To: City Council
From: Jessica Kahn, Public Works Director
Date: August 25, 2025
Re: 9E Cliff Drive Resiliency Project and Local Coastal Program Update

CLIFF DRIVE RESILIENCY PROJECT

August 12, 2025 Community Meeting
Questions & Answers

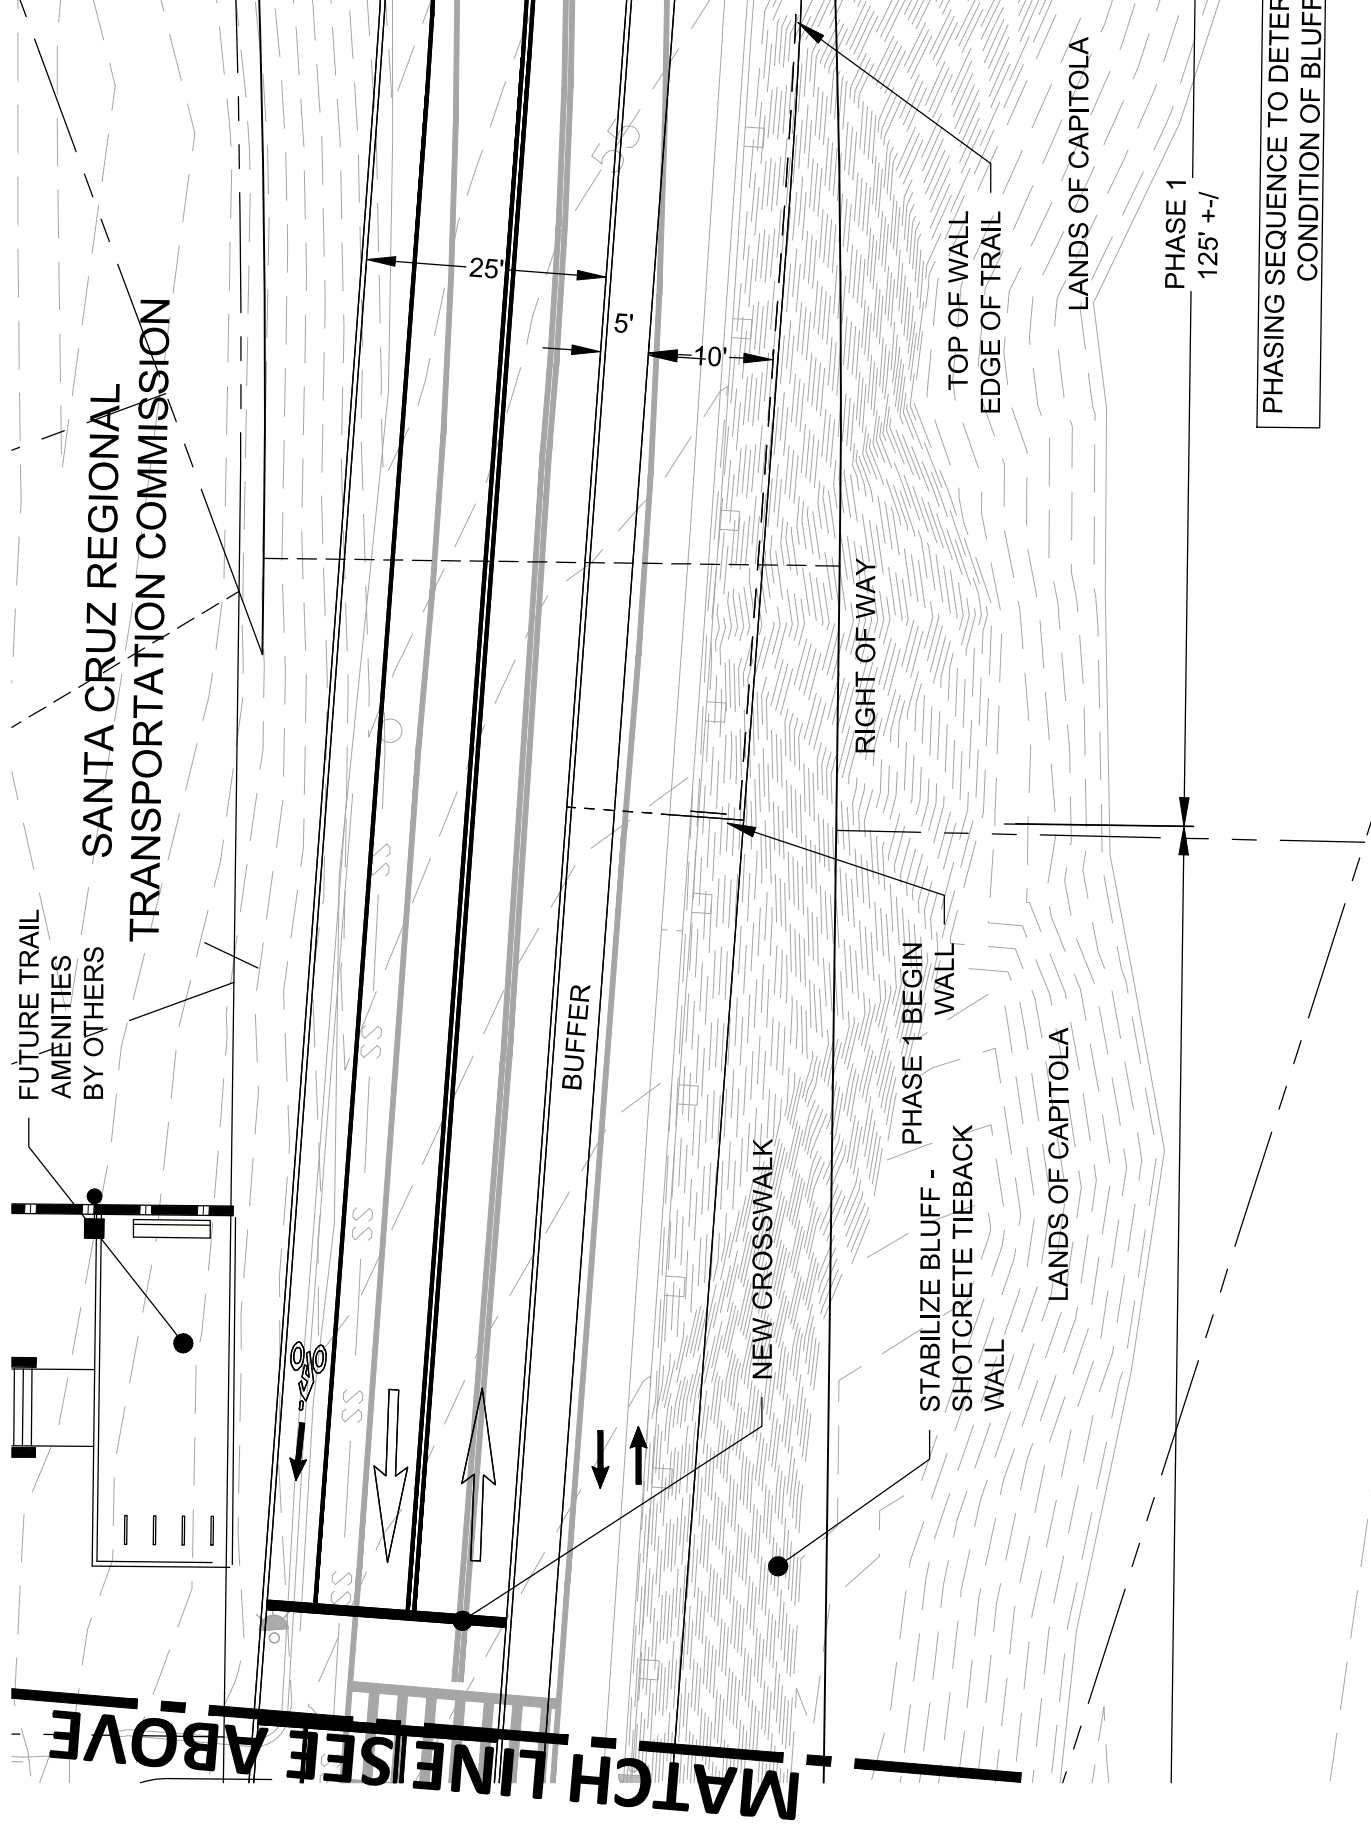
Q7. Why use a cantilevered path, and how far does it extend?

Q8. Will backfill be needed behind the cantilevered walkway?

Q9. Could removing the cantilever reduce costs and allow more seawall to be built?

Q10. How will erosion at the ends of the wall be handled?

A7. The cantilever is necessary to create the planned coastal trail facility. It extends up to about 30 inches.

A8. The old wall will be removed and the new walkway built at the cliff edge. Fill could be added if needed to extend the walkway.

A9. No. The cantilever cost is a small percentage of the overall budget, and eliminating it would not create additional seawall.

A10. The wall ends will be reinforced with additional concrete or RSP to prevent flanking erosion.
